Wardsboro BRF 013-1(15)

Conceptual Value Engineering Proposal

TYPICAL BEAM ELEVATION

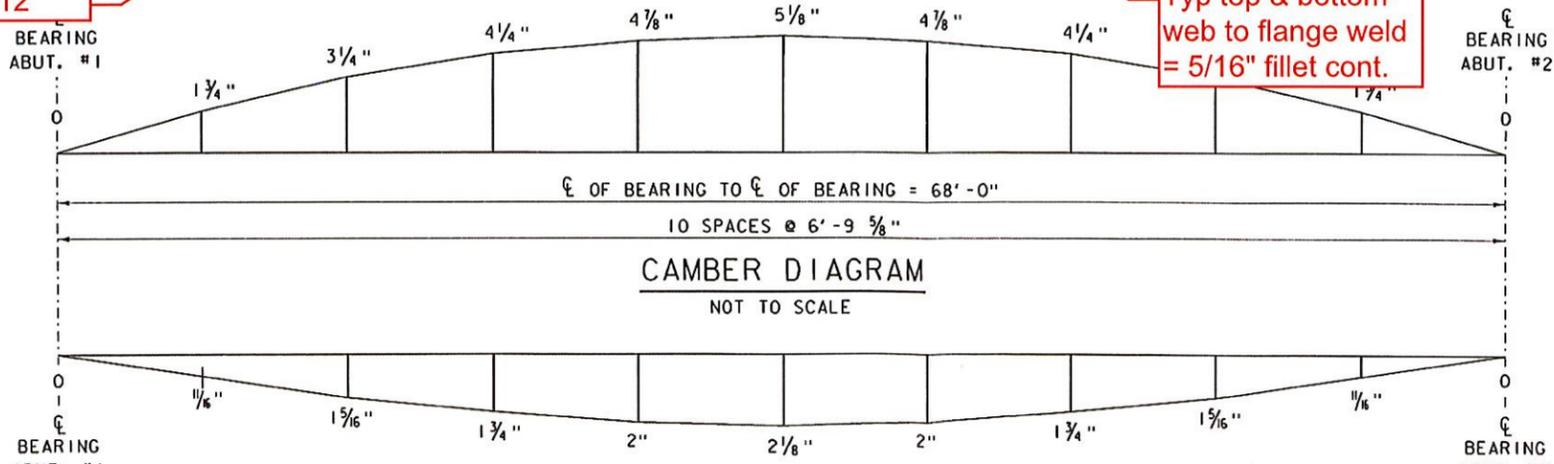
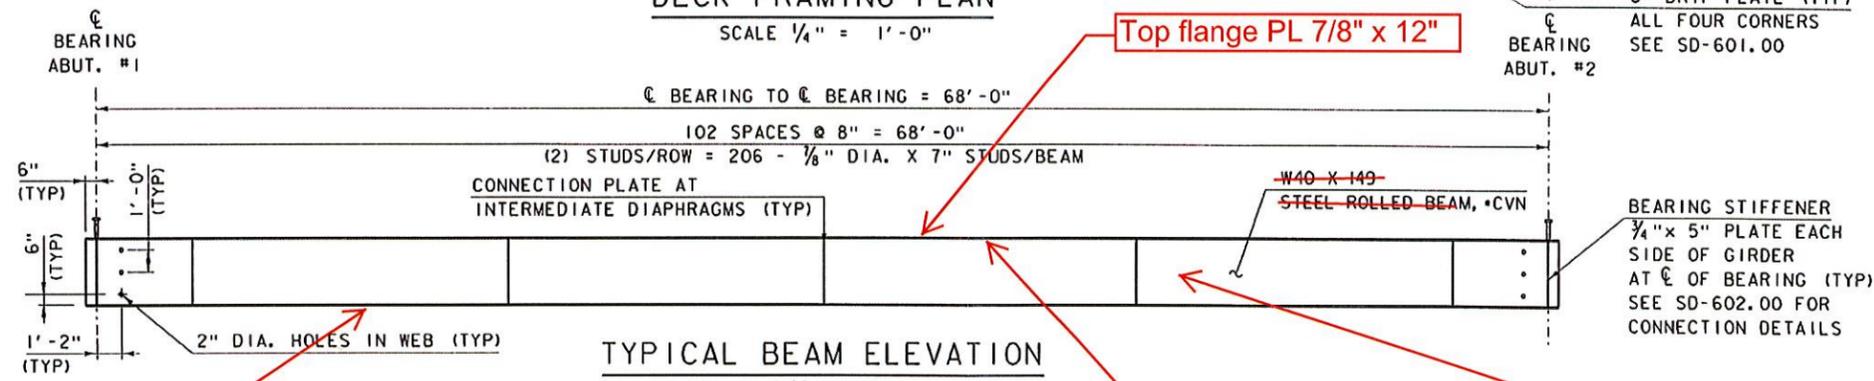
This conceptual value engineering proposal is to use built-up welded plate girders in lieu of the W40 x 149 Rolled Beams. We will utilize the plate sizes as shown on attached marked up Contract Sheet 26 and use a 5/16" fillet weld web to flange.

Bottom Flange PL 7/8" x 12"

Top flange PL 7/8" x 12"

Typ top & bottom web to flange weld = 5/16" fillet cont.

Girder Web - PL 3/4" x 36-3/4" +/-
